Great Lakes UK Limited
Great Wolf Lodge, Chesterton, Bicester

Non Material Amendment (S.96a) Application
Design Changes

March 2023

2.2 Scheme Changes Update Proposed Amended Scheme - Outbuildings

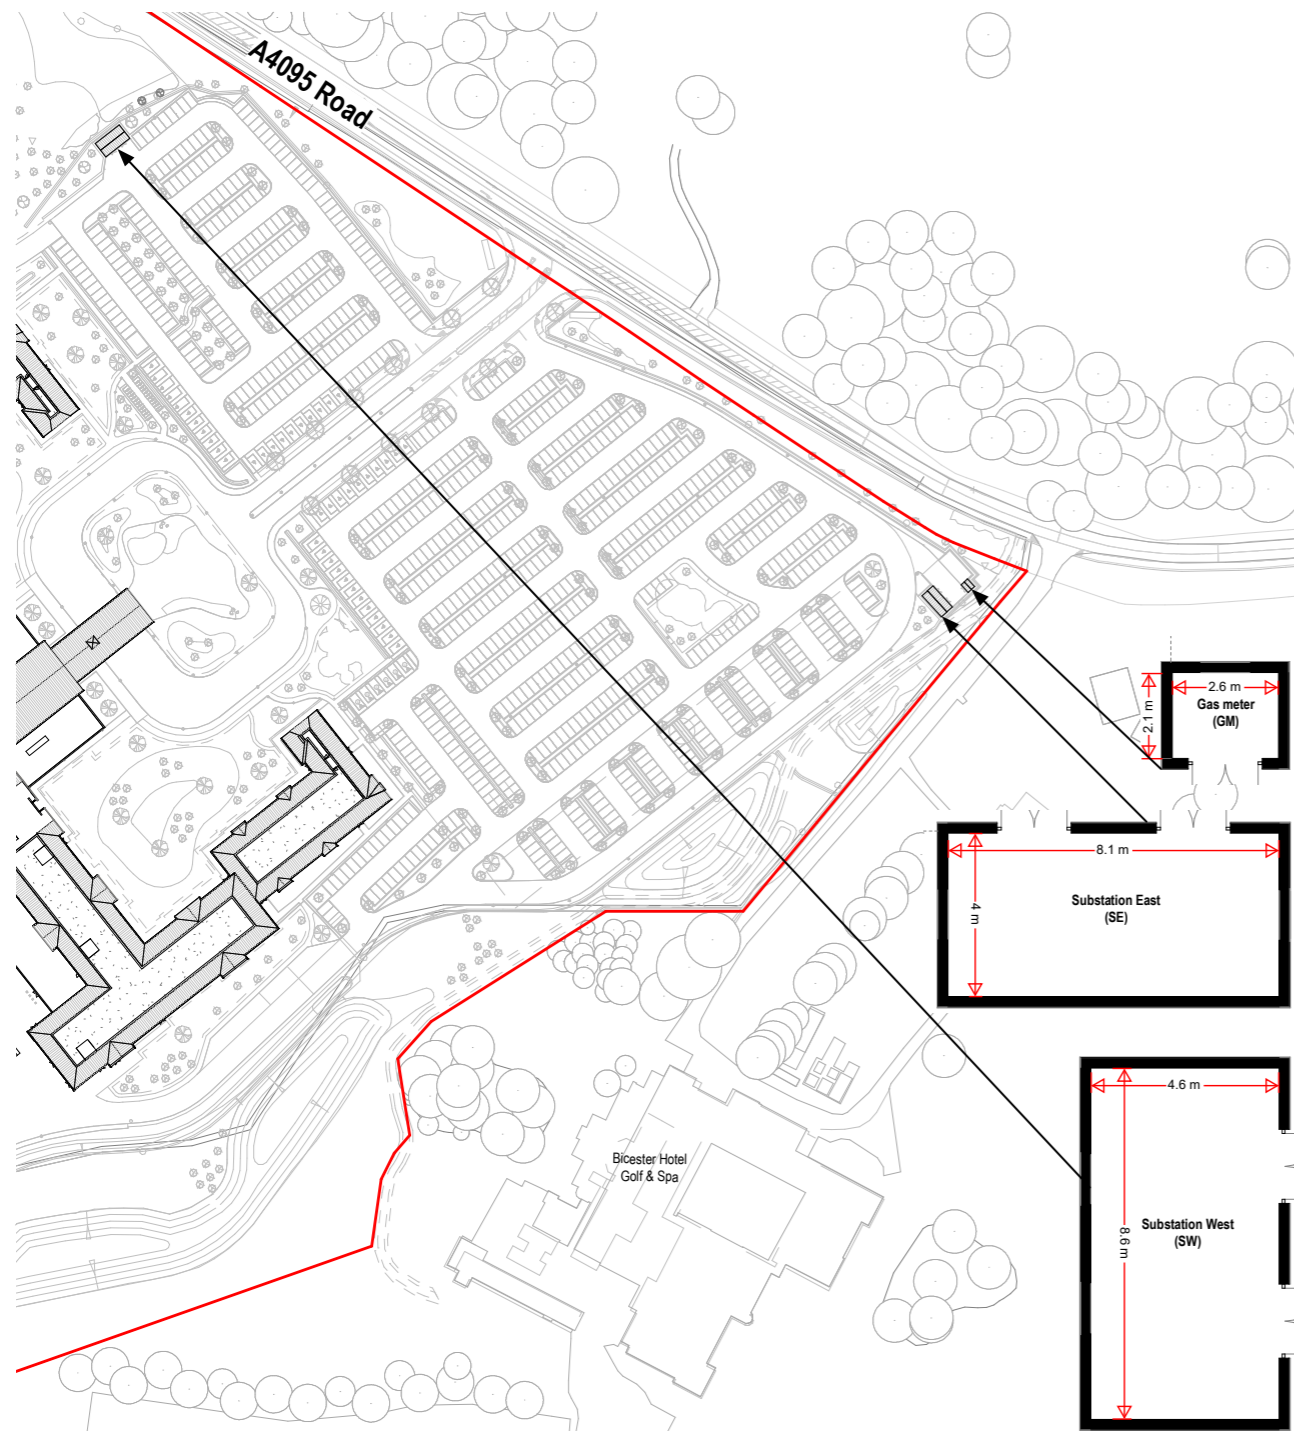
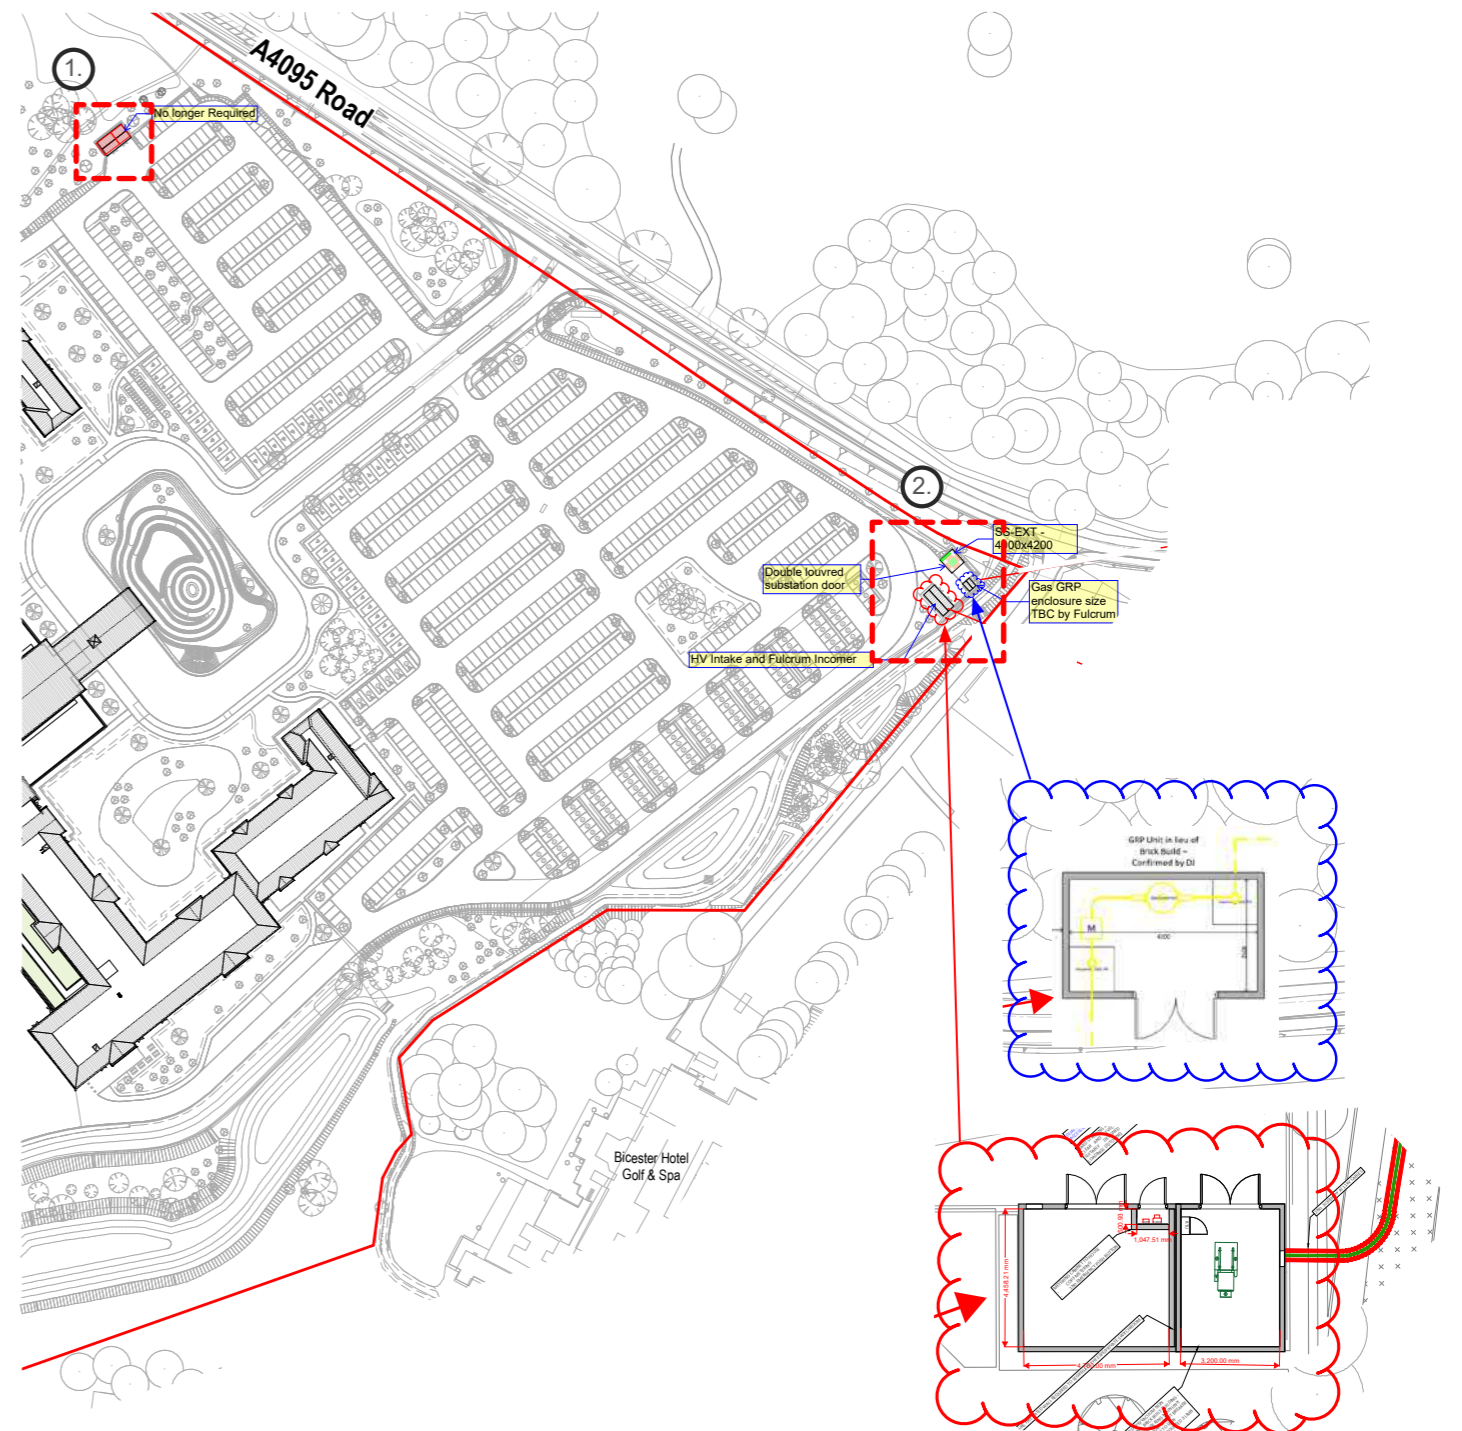
- ① External substation omitted.
- ② External substation and gas intake - change of location, coordination with MEP and structure. Alterations to substations externally within the landscape.

Proposed Amended Scheme - North-West Elevation

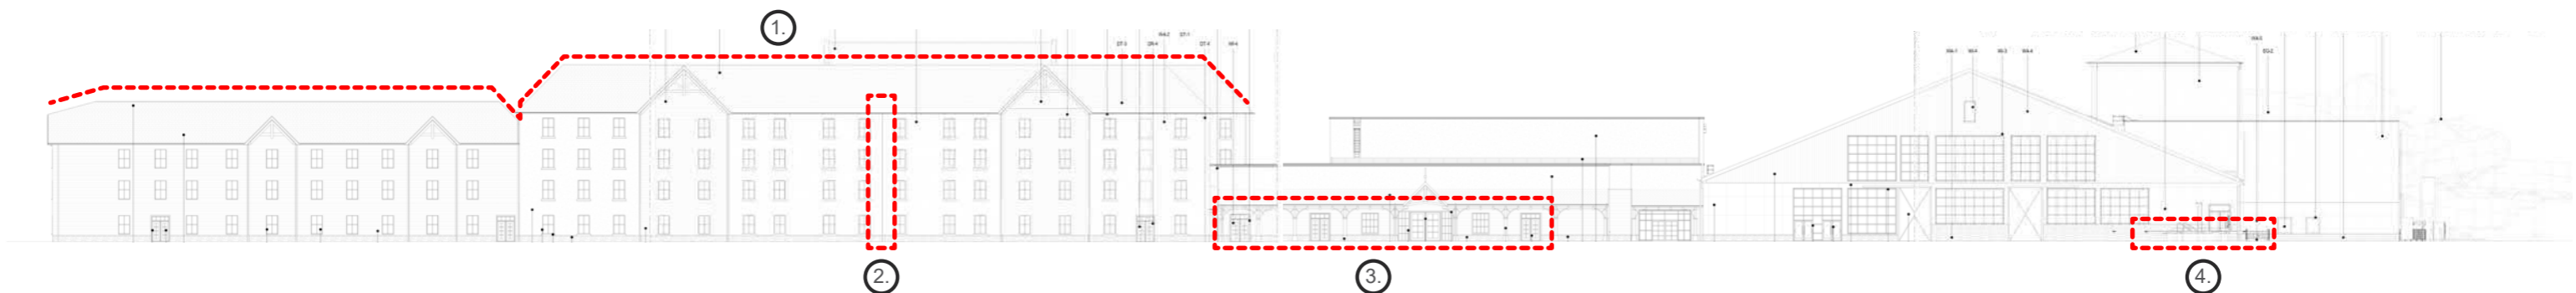
- ① **Reduced** the overall height of the hotel tower.
- ② Moved the rain water pipe on NW elevation.
- ③ Changes to the windows around Buckhorn and around the link corridor to the conference centre. Windows around Buckhorn will get lower, doors at the conference link corridor will get smaller to adjust to the window height.
- ④ WP raised external hot tub area reduced in size from previous permission.

Proposed Amended Scheme - North-West Elevation

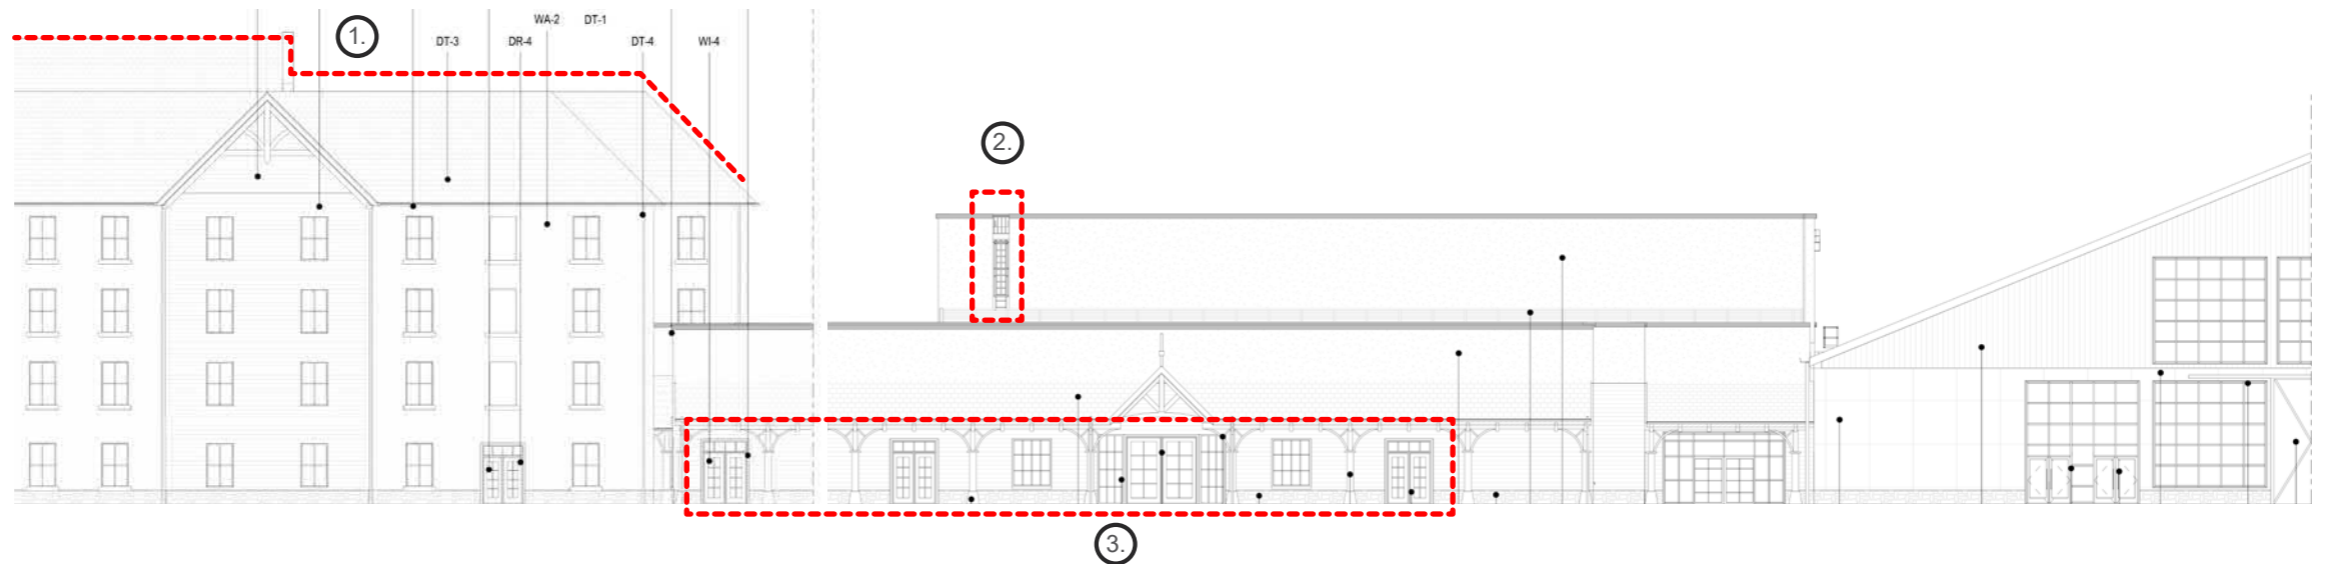
- ① **Reduced** the overall height of the hotel tower.
- ② Ladder added for safe access / egress.
- ③ Fan lights to doors and window heights reduced.

Proposed Amended Scheme - South-West Elevation

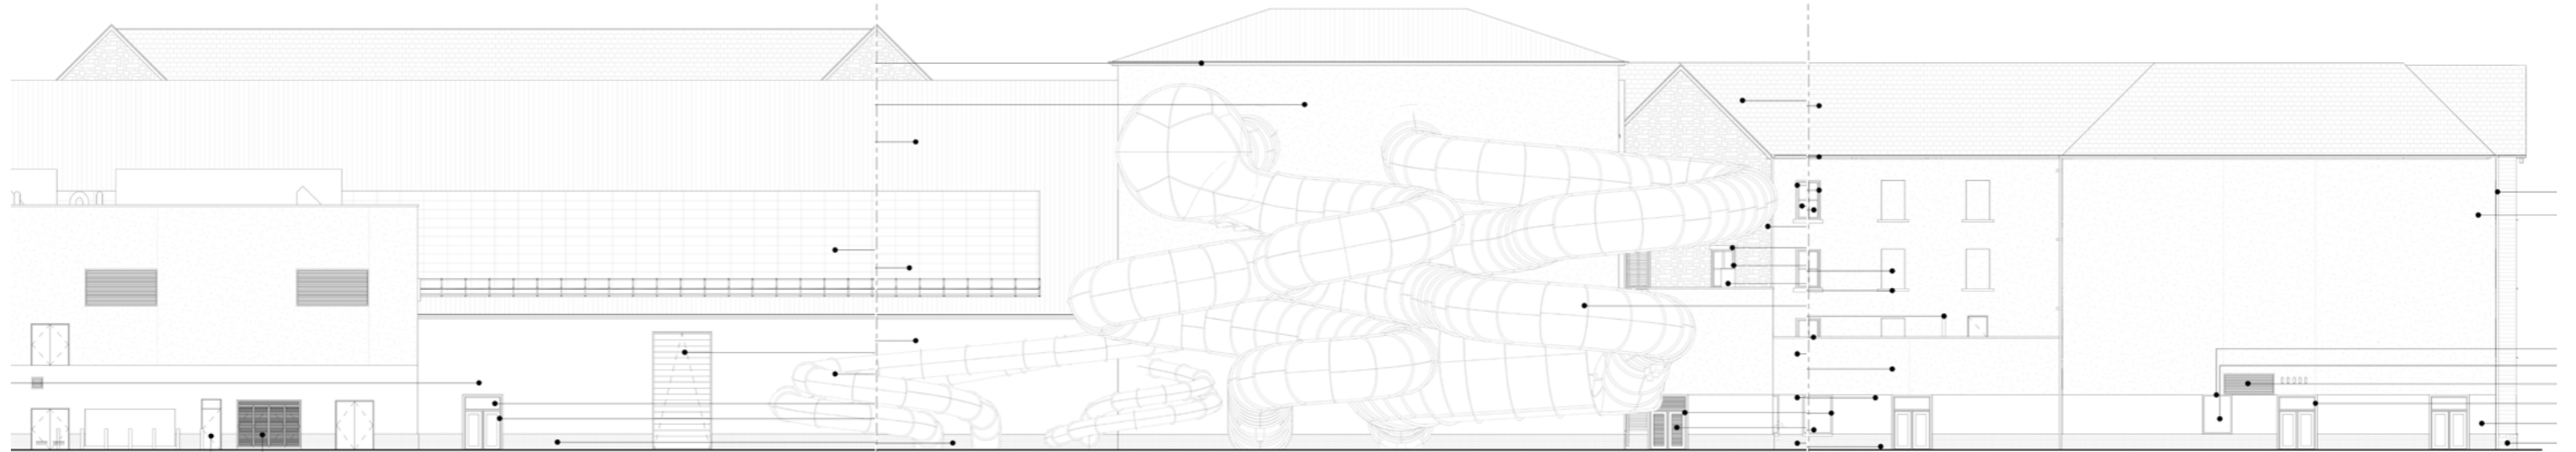
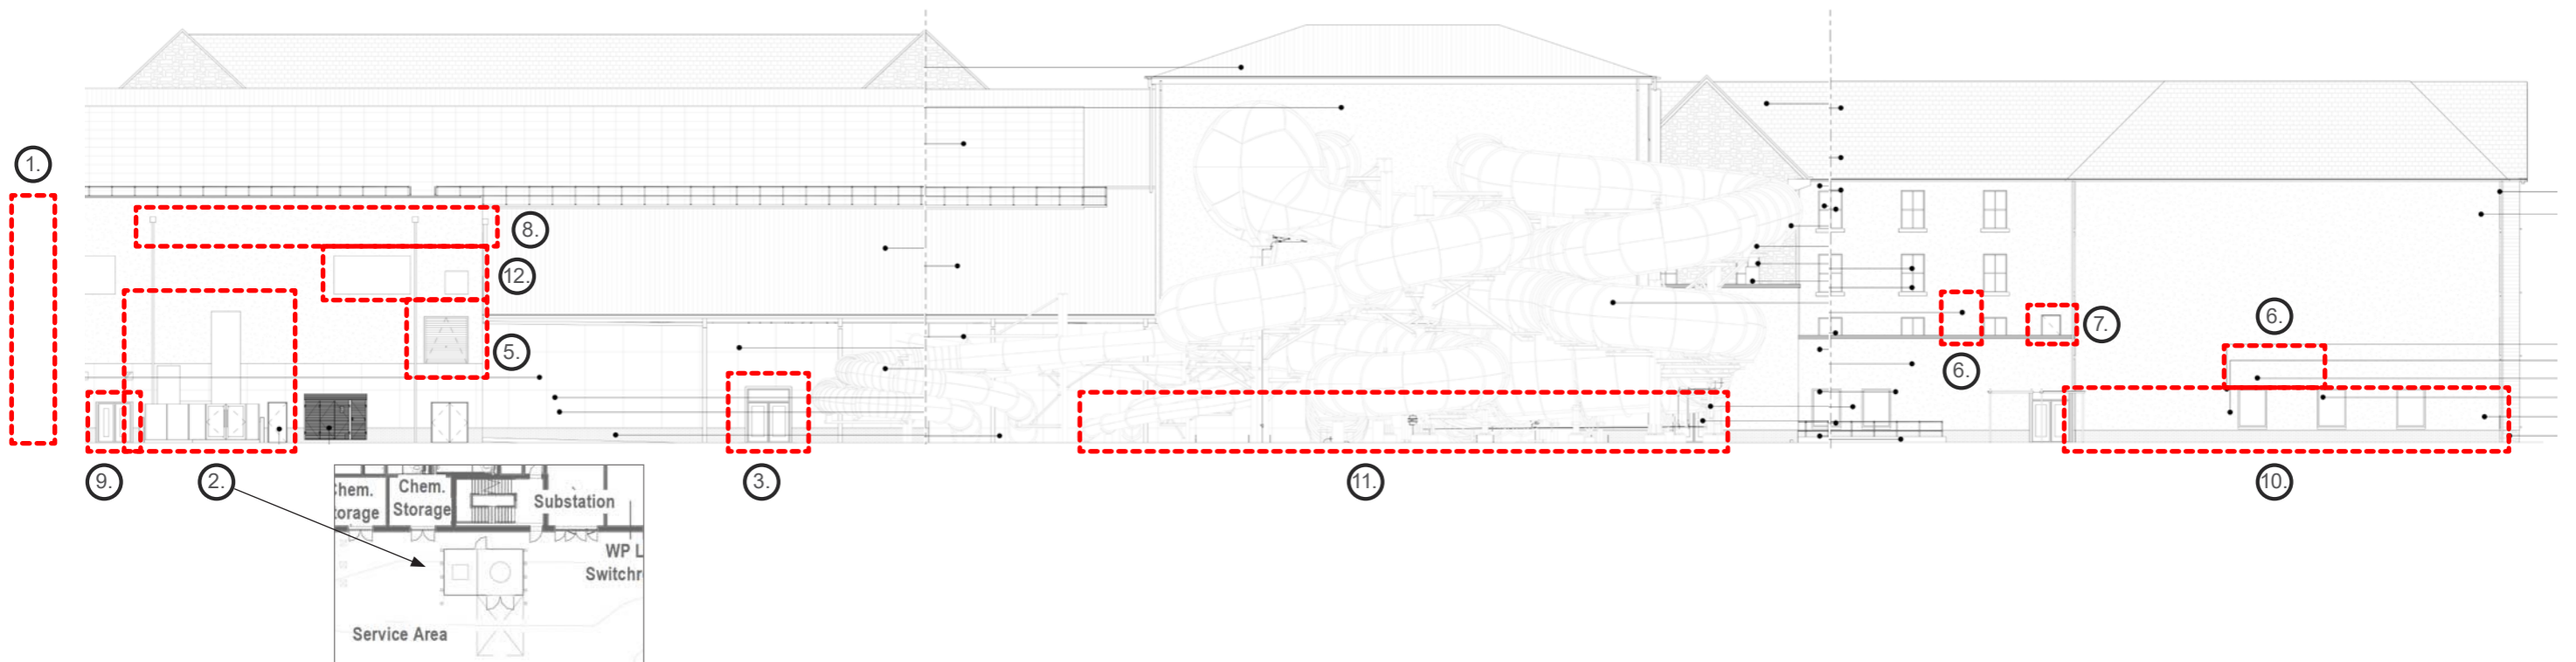
| <ul style="list-style-type: none"> ① New gas pipe added to the bunker building up the external envelope. ② Changes to size of CO2 tank behind bunker and associated enclosure. ③ Additional external door moved to east side of waterpark for fire means of escape purposes. ④ Roller shutter door move and fire escape door moved to south east elevation. ⑤ Plant replacement door on 2nd floor Bunker plant room moved and changed to roller shutter door. ⑥ Flue on green roof and louvres on wall facing service yard to be omitted. | <ul style="list-style-type: none"> ⑦ Door added for safer access onto the roof. ⑧ External rain water pipes and hoppers added to bunker elevations. ⑨ Glazing added to doors for statutory compliance. ⑩ Updated materials on corner of building to enable better construction detailing, and render extended down to masonry plinth. ⑪ Step down in facade levels on corner to enable slide penetrations. ⑫ Louvre numbers, size and positions amended to suit developed MEP design. |
